**RE: Lot 3 Block 5 Unit 18, S.A.D. 227 Unser Cliffs Subdivision
6516 Onyx Ct NW Grading and Drainage Plan
Engineers Stamp Date: 4/10/18 (D10D044)
Pad Certification Date: 6/13/18**

RE: **Lot 3 Block 5, S.A.D. 227**
Unser Cliffs Subdivision
6516 Onyx Ct. NW
Grading and Drainage Plan
Engineers Stamp Date 4-10-18 (E10D044)

LOT 3, BLOCK 5
UNSER CLIFFS SUBDIVISION

LAND - GRADING & DRAINAGE PLAN

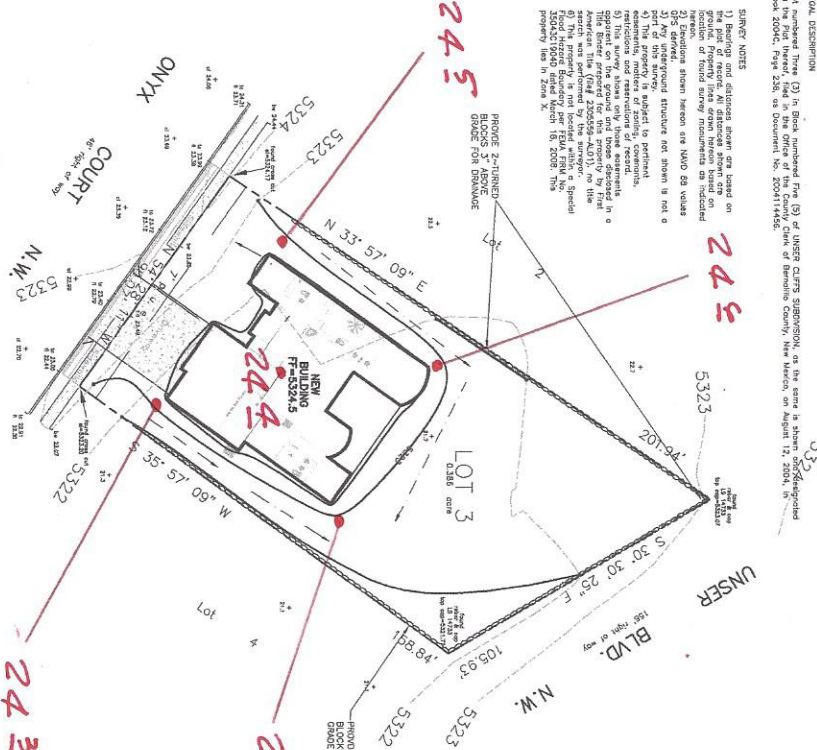
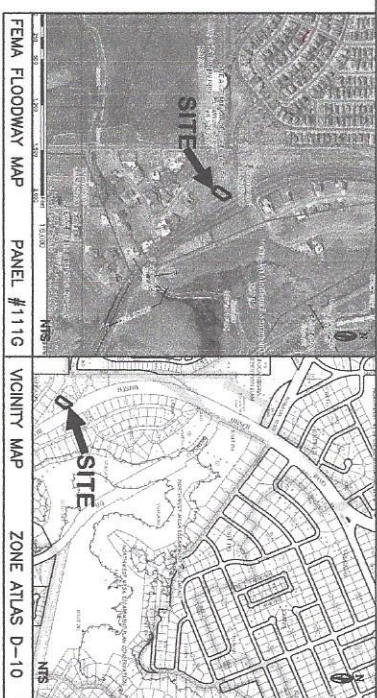
Reiterate to the Owner/Contractor that a separate permit for any garden/retaining wall must be obtained, with the approved G&D plan dated 4/10/18.

Reiterate to the Owner/Contractor that a separate permit for a garden/retaining wall must be obtained, with the approved G&D plan dated 4/10/18.

This is the plan to be used for any garden walls and any openings in the walls shall be placed 3" above final grade in the rear yard to allow for cross lot drainage from west to east (adjacent to downhill).
